WATER PERMIT NO. 1721-1

DESIGN REPORT

PROJECT: Besler Ranch Wetlands Site C
SD -0283-01

REPORT ON
WATER PERMIT APPLICATION NO. 1721-1
Wayne Besler
June 9, 2000

RATING CURVE SITE C

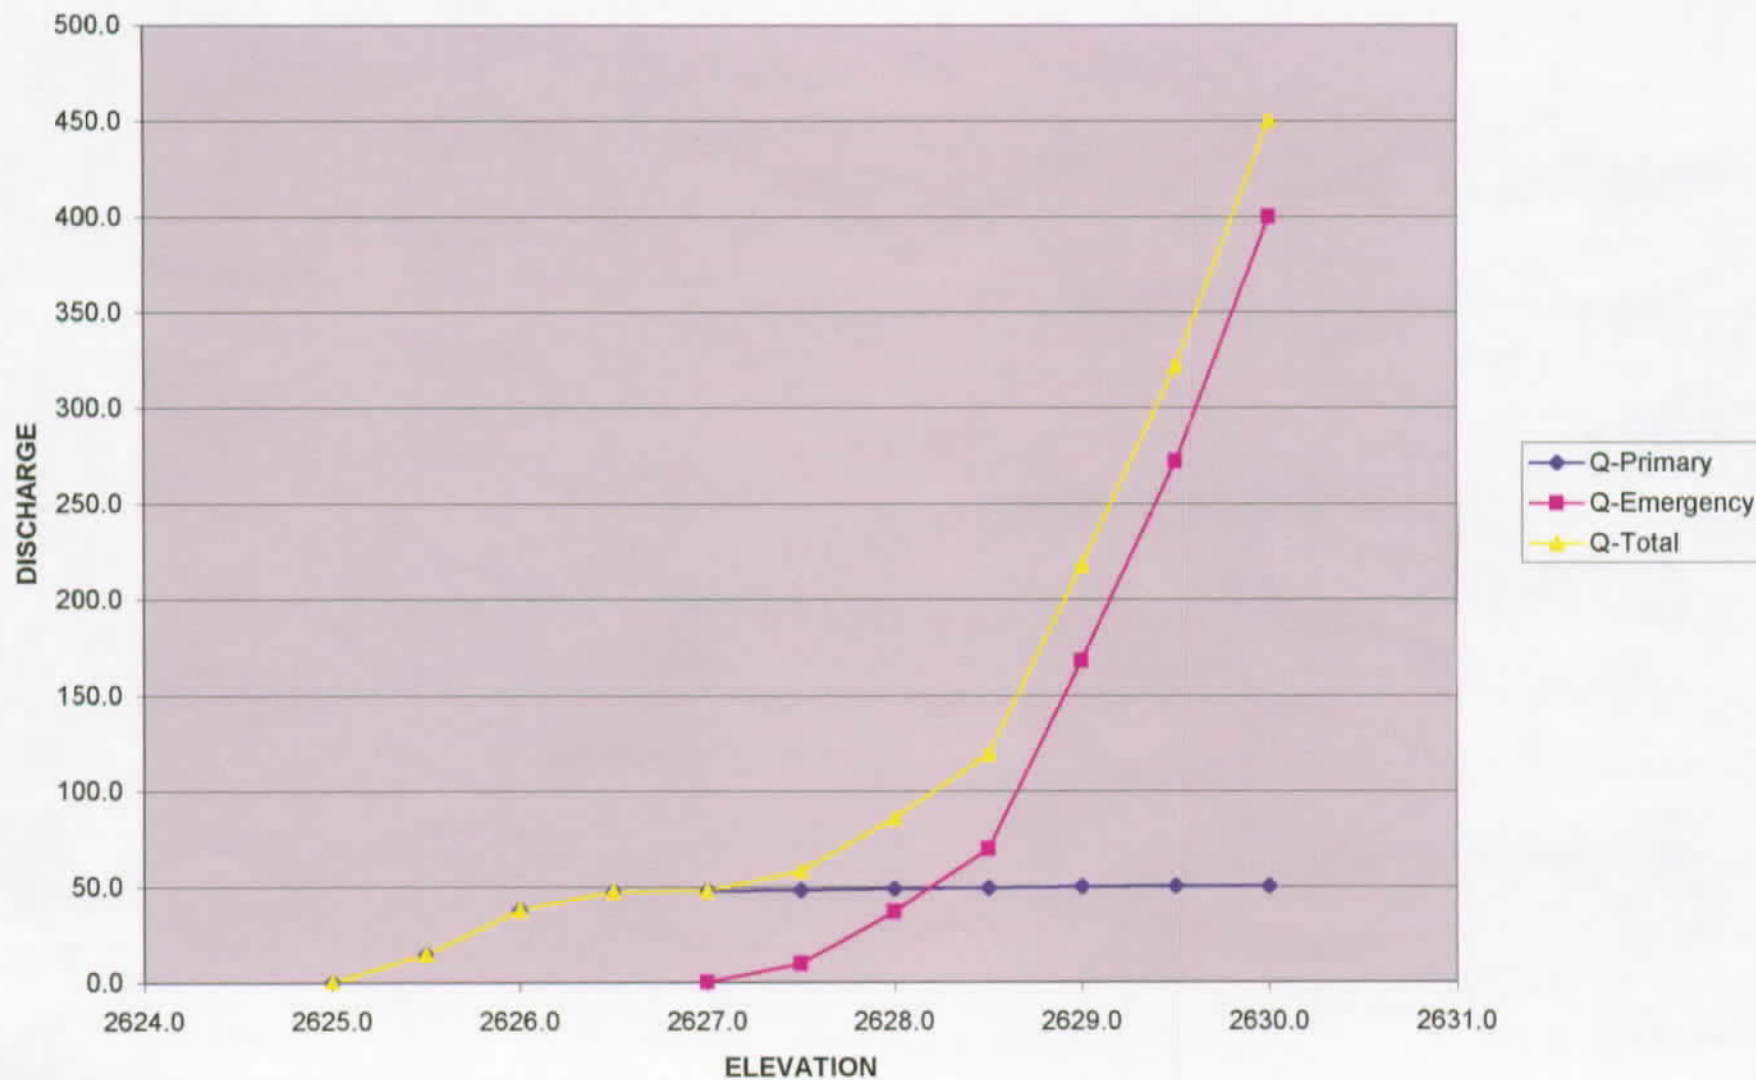
Int Capacity X Eff Ht. = $148 \times 20 = 2960 < 3000 \therefore 25 \text{ yr.}$
Min. Spillway Design

From USGS WRI 80-80 "Tech. for Est. Flood Peaks ... in SD"

DA = 1344 Ac = 2.1 mi²
 Slope = 60 ft/mi
 SI = 2.50

$$\begin{aligned} Q_{15} &= 83.4 A^{.6} S^{.44} S_i^{-.72} \\ &= 83.4 (2.1)^{.6} (60)^{.44} (2.50)^{-.72} \\ &= 83.4 (1.56) (6.06) (0.5170) \\ &= \underline{407 \text{ cfs}} \end{aligned}$$

$$\begin{aligned} Q_{100} &= 132 A^{.65} S^{.46} S_i^{-.67} \\ &= 132 (2.1)^{.65} (60)^{.46} (2.50)^{-.67} \\ &= 132 (1.62) (6.57) (0.5412) \\ &= \underline{760 \text{ cfs}} \end{aligned}$$

Secondary Spillway Flow

$$\begin{aligned} Q &= CLH^{3/2} C = 2.6 \\ &= 2.6(40 \times 3)^{1.5} L = 40 \\ &= \underline{540 \text{ cfs}} H = 3 \end{aligned}$$

NRCS Annual Yield

DA = 1344 Ac ISO = 1.5 CN = 75

$$\begin{aligned} 80\% \text{ chance} &= 0.09 \\ 0.09 \times 1344/12 &= \underline{11 \text{ Ac.-Ft}} \end{aligned}$$

$$\begin{aligned} 50\% \text{ chance} &= 0.25 \\ 0.25 \times 1344/12 &= \underline{28 \text{ Ac.-Ft}} \end{aligned}$$

$$\begin{aligned} 10\% \text{ chance} &= 1.40 \\ 1.40 \times 1344/12 &= \underline{156 \text{ Ac.-Ft}} \end{aligned}$$

Section 74:02:08:09

1. Topo Map - OK
2. Dam Axis Profile - OK
3. Dam Max. X-Sec. - OK
4. Area Capacity - OK
5. Outlet Details - OK
6. Spillway Rating - OK
7. Spillway Details - OK
8. Specs - Std. DV - OK
9. EPP - N/A Cat. 3 - OK
